City of Carroll

SUBJECT: Water Distribution Main Replacements - 2020
Work Change Directives Nos. 1 and 2

WORK CHANGE DIRECTIVE NO. | 1
DATE | 7/6/20
PROJECT | Water Distribution Main Replacements - 2020
JEO PROJECT NO. | 191586.00
LOCATION | Carroll, Iowa
OWNER | City of Carroll
CONTRACTOR | King Construction

WORK CHANGE DIRECTIVE NO. | 2
DATE | 7/6/20
PROJECT | Water Distribution Main Replacements - 2020
JEO PROJECT NO. | 191586.00
LOCATION | Carroll, Iowa
OWNER | City of Carroll
CONTRACTOR | King Construction

PLAN AND PROFILE D.01

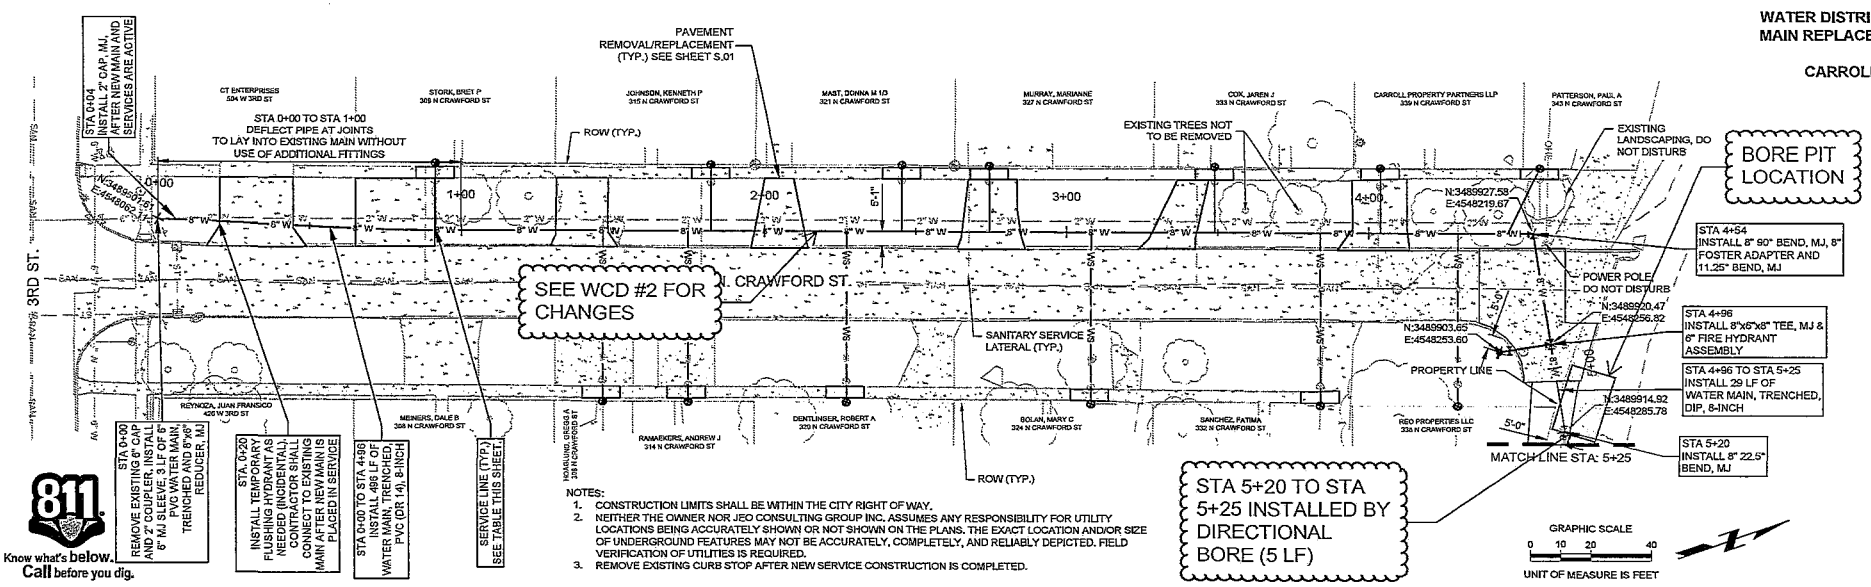
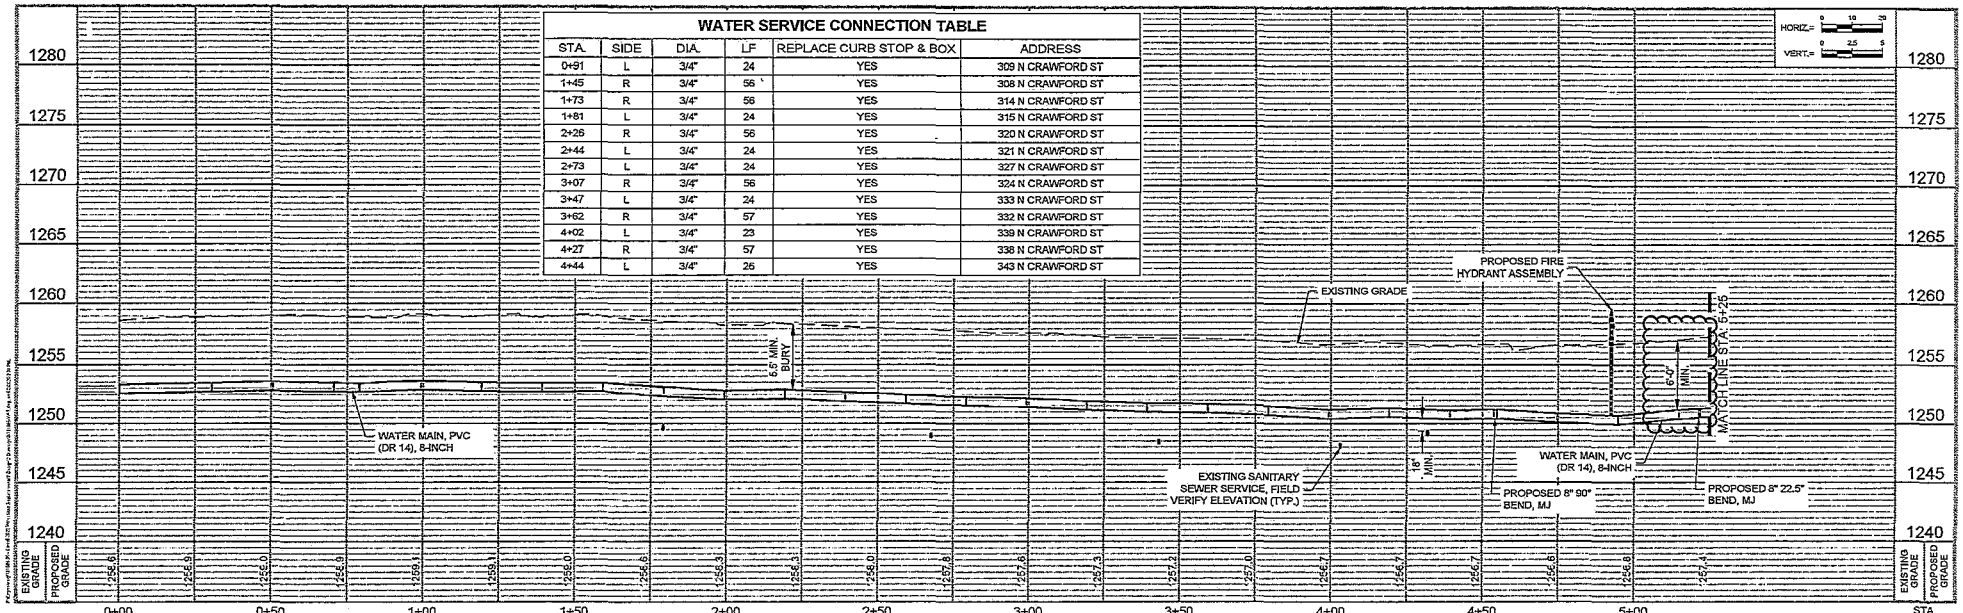
You are directed to proceed promptly with the following change(s):
Description Install 8" ductile iron pipe by directional bore at 6 foot bury along UPRR right of way with approximate excavation and bore pit locations shown on the attached plan sheets.
Purpose of Change Directive Compliance with UPRR Permit conditions.
Attachment(s) Revised sheets C.01, D.01 to D.03; Changes to the work; Contract Price Change Estimate

1. The alignment along UPRR railroad right of way is to be 8" ductile iron pipe, directionally bored at 6-foot depth. Contractor to verify bore pit location and dimensions on the provided plan sheets.
2. Contractor shall conduct work in a manner to minimize duration of work on UPRR right of way, including boring pit locations and boring operations.
3. Bid Item 44 – "WATER MAIN, TRENCHED, DIP (CL52), 8-INCH" is established as a part of the contract. prices, quantities, and estimate reference information shall be as shown on the figures and pricing change sheet.
4. Bid Item 45 – "WATER MAIN, TRENCHLESS, DIP, RESTRAINED JOINT (CL52), 8-INCH" is established as a part of the contract. prices, quantities, and estimate reference information shall be as shown on the figures and pricing change sheet.

PLAN AND PROFILE D.01

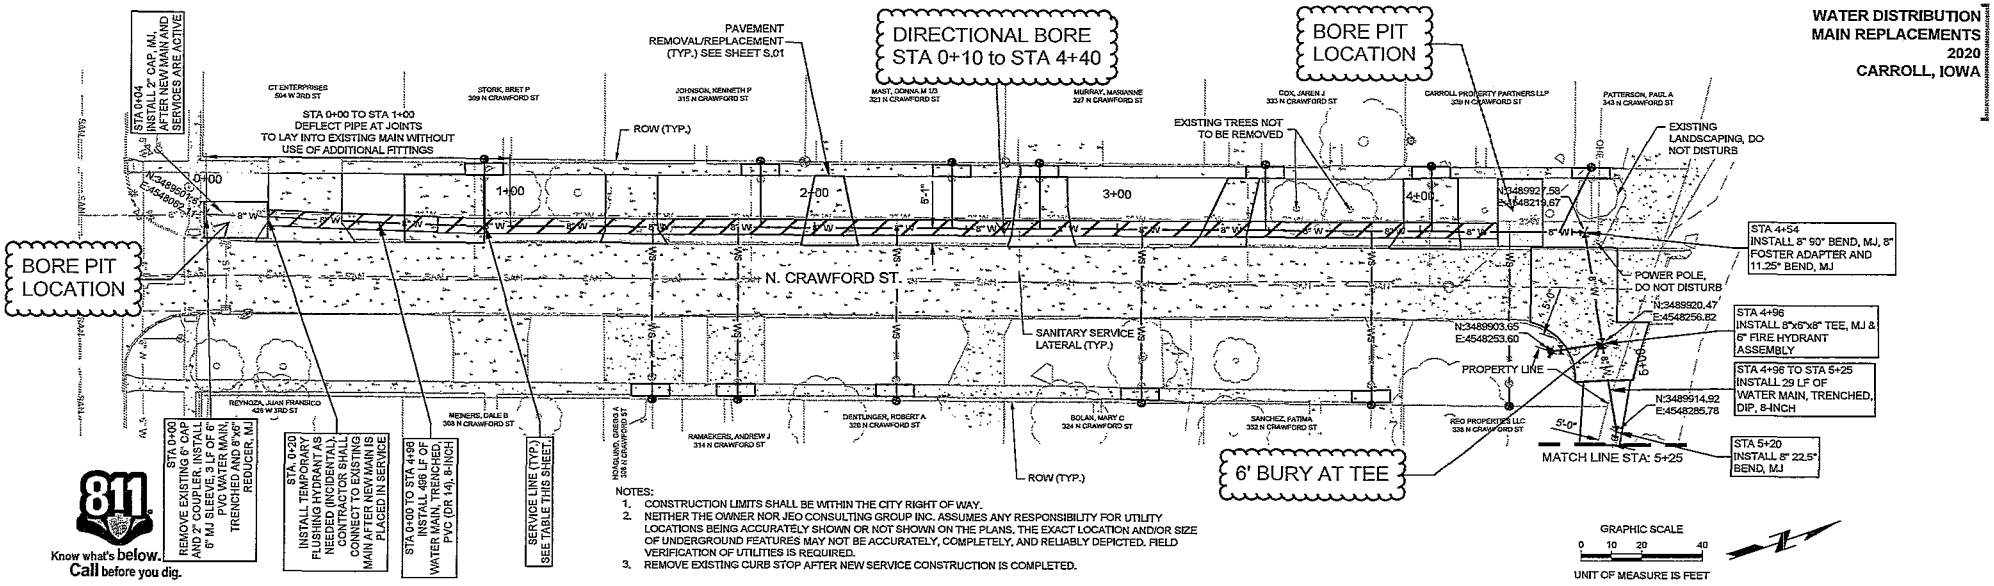
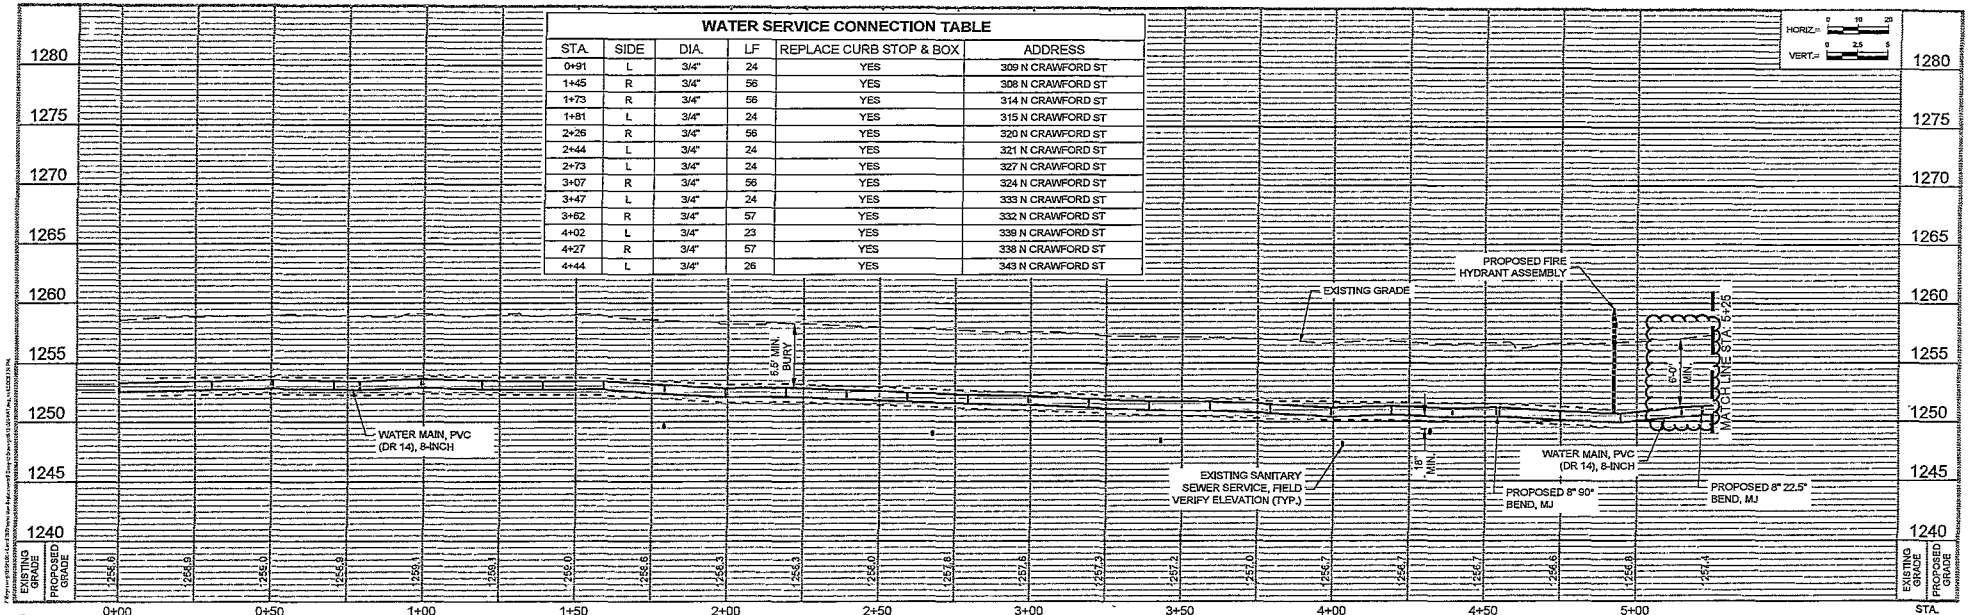
You are directed to proceed promptly with the following change(s):
Description Install water main by directional bore as shown on the attached plan sheets.
Purpose of Change Directive Contractor's proposal, decrease impact to adjacent property owners.
Attachment(s) Revised sheets D.01, D.04, D.05, D.06, D.07, D.08; Changes to the work; Contract Price Change Estimate

1. The contractor is to bore the alignments as shown on the attached plan sheets.
2. Measurement for the work will be by the linear foot and will not include locations installed by open cut.
